Notice of Allowability	Application No.	Applicant(s)	
	10/605,778	RODNUNSKY, JIM	
	Examiner	Art Unit	
	Mark T. Le	3617

EXAMINER'S AMENDMENT

Fig. 7

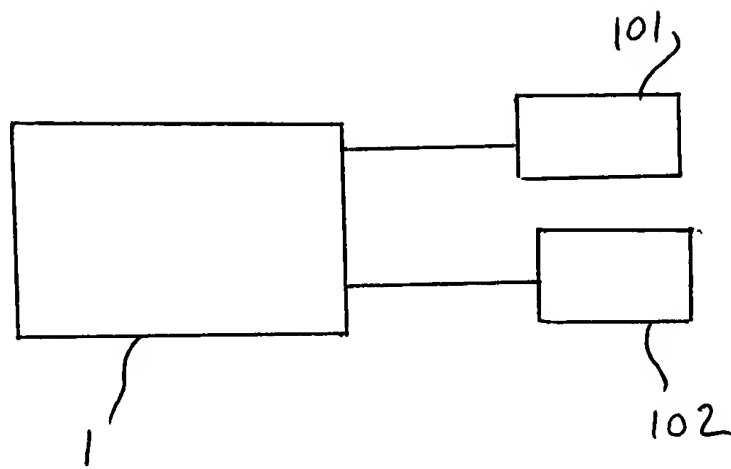
New formal drawing Figure 7, as shown in the attached Examiner's Proposed New Drawings, is now required..

5. Regarding the above amendments to the specification and the addition of the new drawing, they are necessary to show the instant claimed computer associated with other structures of the instant claimed invention, as required under 37 CFR 1.83(a).

-- [0022a] Figure 7 is a schematic of a control system. --.
